PRODUCT BULLETIN

Bulletin No: PB381

Change to N51-01, N51-05, N51-06

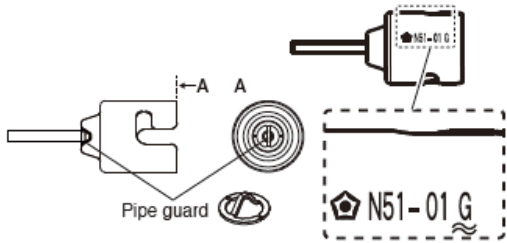
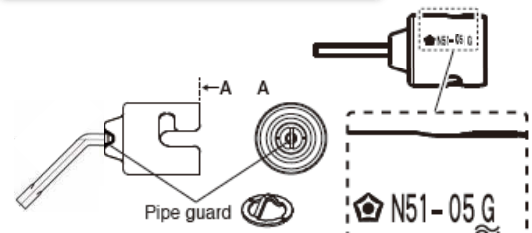
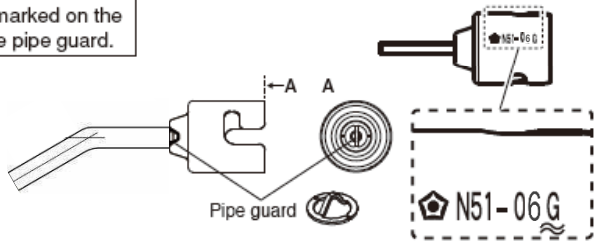
NOTE :
Letter "G" is marked on the nozzle with the pipe guard.

NOTE :
Letter "G" is marked on the nozzle with the pipe guard.

NOTE :
Letter "G" is marked on the nozzle with the pipe guard.

The N51-01, N51-05 and N51-06 nozzles have changed with an upgraded pipe guard that will prevent the use of the vacuum pickup and will prevent damage to the unit. The new nozzles will be denoted on the outside of the nozzle by a "G" following the part number.

Note: If using an older N51-01, N51-05 or N51-06 without a "G" denoted on the outside of the nozzle, do not use the vacuum pickup feature as you can cause damage to your unit. Please refer to PB378 FR-810B Hot Air Rework Station and the FR-810B User Manual, Section 4 for more information.
